0	F	30.07.24	FOR APPROVAL	AJD	AJD	IES	SES
REV.	STATUS	DATE	PURPOSE OF ISSUE	PREP.	CHKD.	APPD.	AUTH.
<small>CLIENT: ENER TECHNOLOGI</small> <small>SERVICE: PROPANE REFRIGERATION PACKAGE</small> <small>LOCATION: IRAQ</small> <small>UNIT TAG NO.: RU-001 AB</small>							
<small>VENDOR LOGO</small>							
<small>Contract No.</small>		<small>P.O. No.</small> ENER-MME-2024-100-001		<small>SCALE</small>			
<small>DRAWING TITLE:</small> PRESSURE TRANSMITTER TUBING SUPPORT							
<small>DRAWING NO.</small> MPE007- PIT-RU0001A-SPRT				<small>REV.</small> 0	<small>SHEET No.</small> 1 OF 1	<small>SIZE</small> D

ANGLE SUPPORT 3 X 3 X 1/4

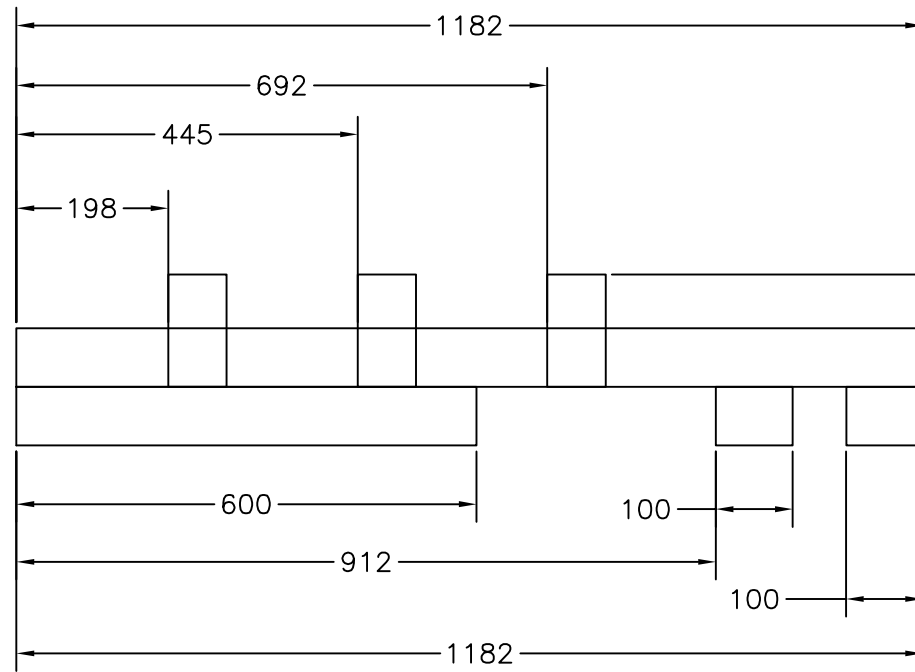
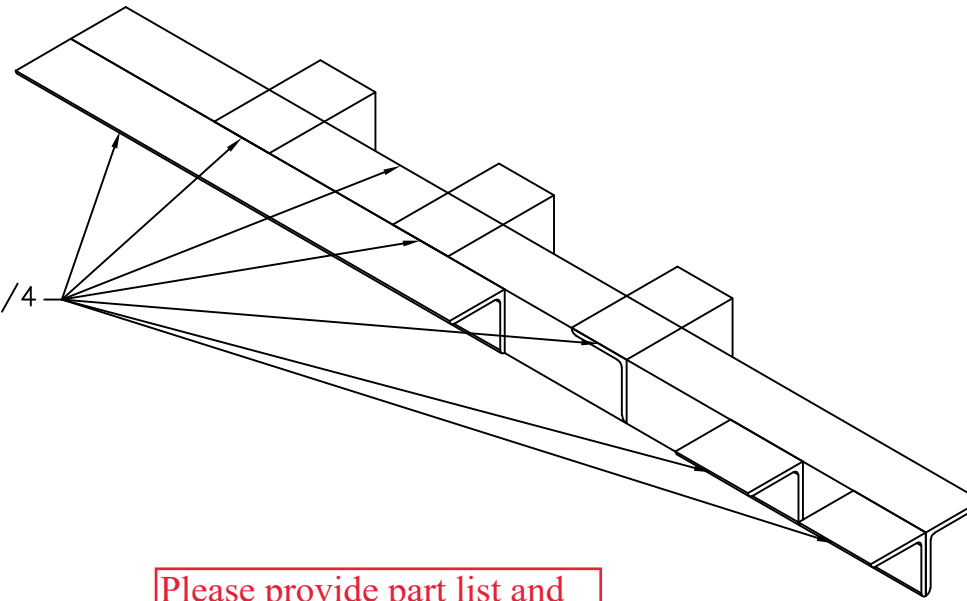
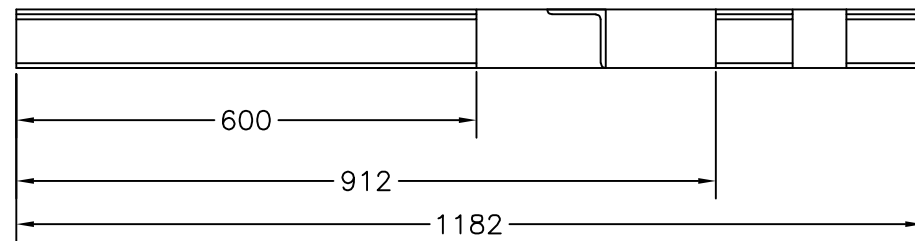
Please provide part list and Material

Please specify this dimension

MME: BOM NOT REQUIRED AS THE IDENTIFYING LEADERS ARE SELF EXPLANATORY, AS ADVISED BY ISSAM. HOWEVER, IN ORDER TO ACCOMODATE THE MODIFICATIONS ADVISED WITH RESPECT TO THE ADDITION OF THE 2-WAY MANIFOLD, THIS SUPPORT DRAWING NEEDS TO BE UPDATED. THE REVISED DRAWING WILL BE FORWARDED SOON.

MME : CLEARLY MENTIONED AS ANGLE SIZE 3" (76 MM).
